Model: Leo-C1a/C1b (D194/D195)	Date: 23-Feb-15	No.: RD777001b
--------------------------------	-----------------	----------------

Subject: Adjustments in Vacuum Feed LCIT to prevent no-feed and double-feed jams		Prepared by: Shinnosuke Sasaki	
From: 1st PP Tech Service Sec., PP Tech Service Dept.,			
Classification:	<input checked="" type="checkbox"/> Troubleshooting <input type="checkbox"/> Mechanical <input type="checkbox"/> Paper path <input type="checkbox"/> Product Safety	<input type="checkbox"/> Part information <input type="checkbox"/> Electrical <input type="checkbox"/> Transmit/receive <input type="checkbox"/> Other (     )	<input type="checkbox"/> Action required <input type="checkbox"/> Service manual revision <input type="checkbox"/> Retrofit information <input type="checkbox"/> Tier 2

Model: Vacuum Feed LCIT RT5100		Date: 29-Jul-15	No.: RD077002
Subject: Part Catalog Correction Vacuum Feed LCIT RT5100 – Joint bracket		Prepared by: Takezoh Miyamoto	
From: 1st PP Tech Service Sec., PP Tech Service Dept.,			
Classification:	<input type="checkbox"/> Troubleshooting <input type="checkbox"/> Mechanical <input type="checkbox"/> Paper path <input type="checkbox"/> Product Sa

## CAUSE

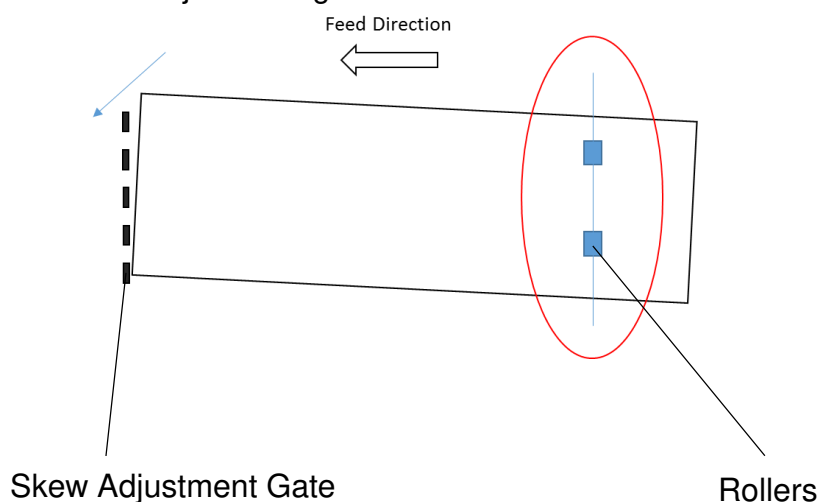
Skew occurs when a banner sheet is fed from the Vacuum Feed LCIT.

The skew of the banner sheet cannot be corrected efficiently with the skew adjustment gate, because the trailing edge of the banner sheet is still held by rollers when the leading edge reaches the adjustment gate.

Apply the skew adjustment plates under the connection pins on the mainframe following the procedure described in this document, in order to adjust the angle with which the LCIT is connected to the mainframe.

8 adjustment plates come with the Vacuum Feed LCIT. Adding 1 adjustment plate will correct approx 0.25mm/100mm of skew. Up to 4 plates can be inserted under the pin, which means approx 1.0mm/100mm of skew can be corrected.

## SYMPTOM

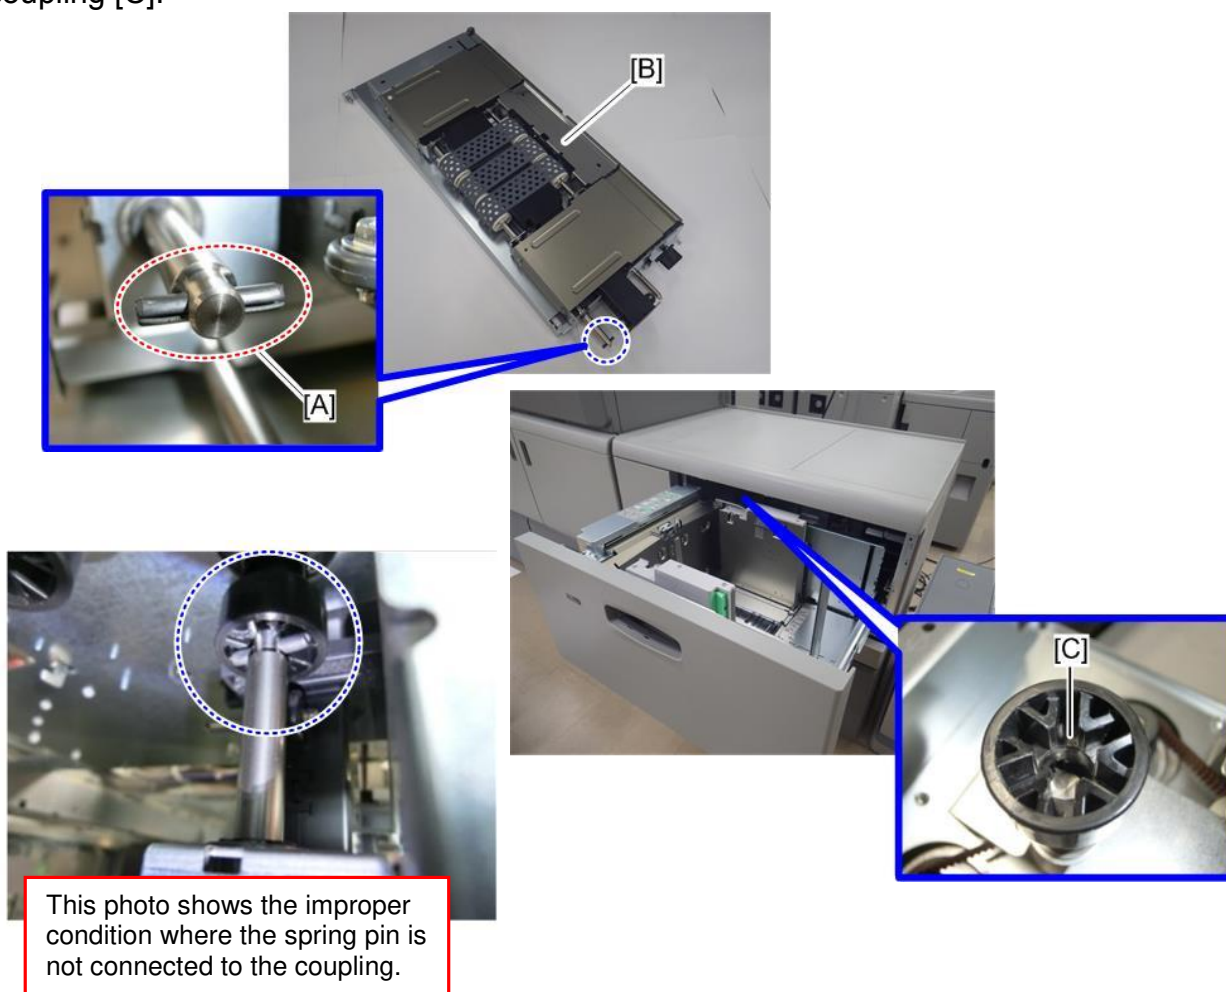
J430: LCT1 Paper Feed Sensor (Tray1)

J431: LCT1 Paper Feed Sensor (Tray2)

Paper cannot be fed, because the spring pin [A] located at the rear side of the paper feed belt unit [B] (of the main machine or Vacuum Feed LCIT RT5100) is not connected to the coupling [C].

Connect the spring pin to the coupling with the following procedure. The procedure is the same for the paper feed belt unit of the main machine and of the Vacuum Feed LCIT RT5100, and can be performed either when the main power switch is turned ON or OFF.

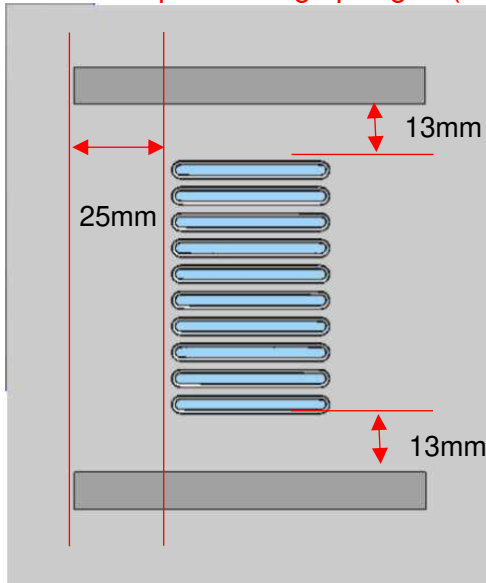
The exhaust fan filter becomes clogged with paper dust.

4. Attach the positioning sponges (D7771294) as follows.

5. Attach the filter assembly (P/N D7771295).

D7772615 SIDE PLATE: TRAY: FRONT: PEEN

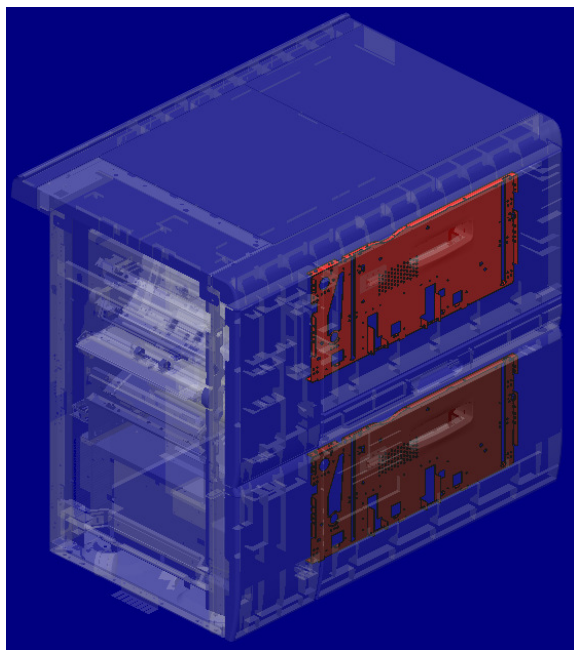
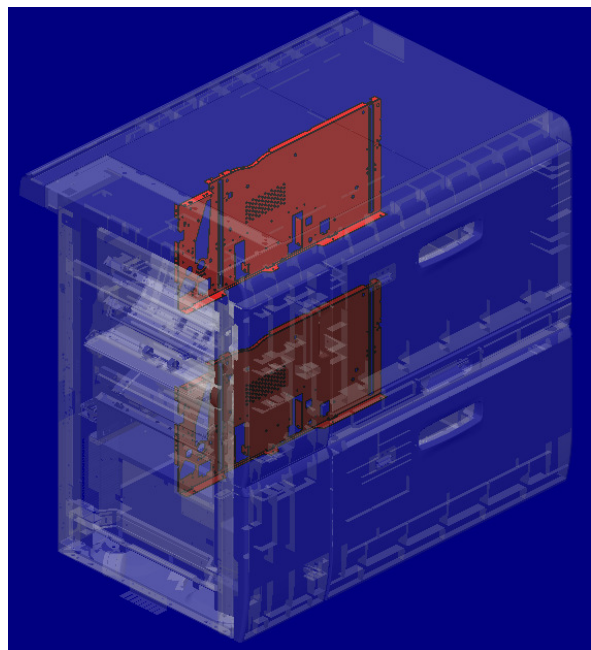
The following parts were registered as new service parts to meet requests received from the field.

Take note of the following points when replacing the newly registered Side Plates, because the bracket is attached with the float/separation fan and duct. See photo below, which is a shot of the tray taken from the left hand side.

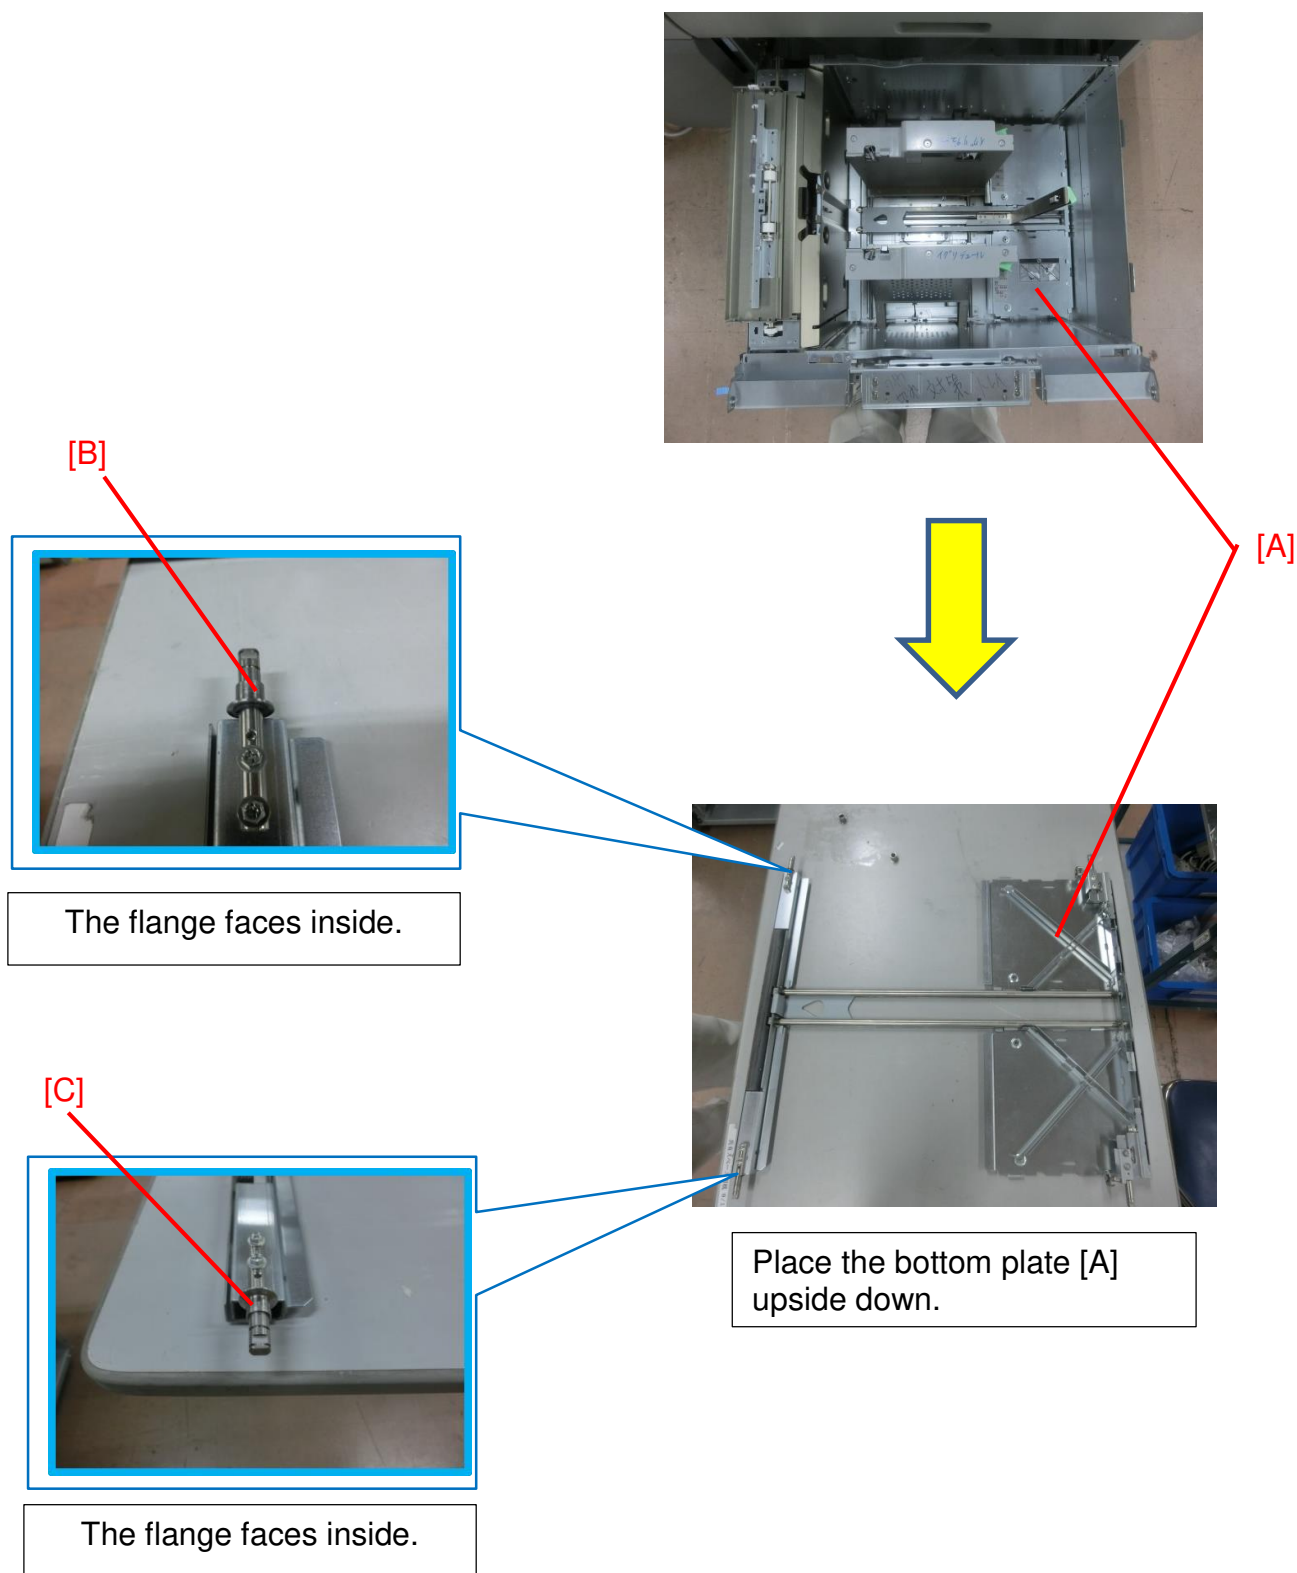
The following parts were modified to prevent the tray lift wire from breaking.

4. Remove the bottom plate [A] from the tray and place it upside down on a flat sturdy table or a bench, and then replace the collars [B] and [C] with the new type collars.

**NOTE:** The new type collars are tapered.

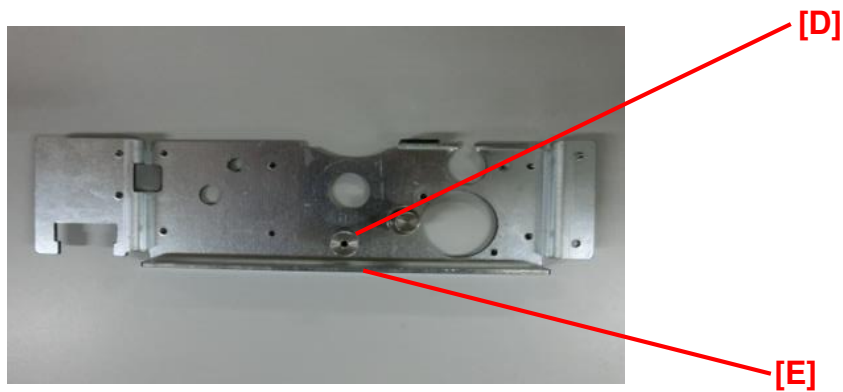
10. Replace the bracket [A] removed in Step 9 with the new type bracket [B] (call-out [#1] in the table on page 1).

**NOTE:** The new type bracket [B] has an additional stud [D] and a bent edge [E].

## How to replace the gear

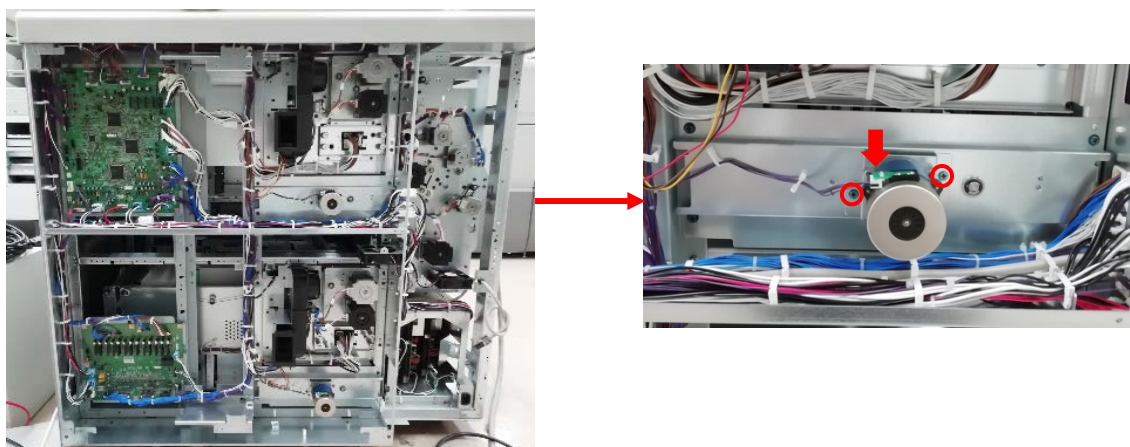
**Change:** Idle gear of the tray bottom plate lift motor

**Request:** If the gear breaks, replace it with the above new gear. Note that replacing with the old gear may cause the gear to break again.

1. Remove the rear right and left covers.
2. Remove and the LCIT lift motor. (Screw x2, Connector x1)

3. Remove the tray lift drive unit. (Screw x4, Clamp x2)

4. Remove the E-type retaining ring and the two screws on the back side, to remove the gear box.

5. Replace the idle gear. (E-type retaining ring x1)
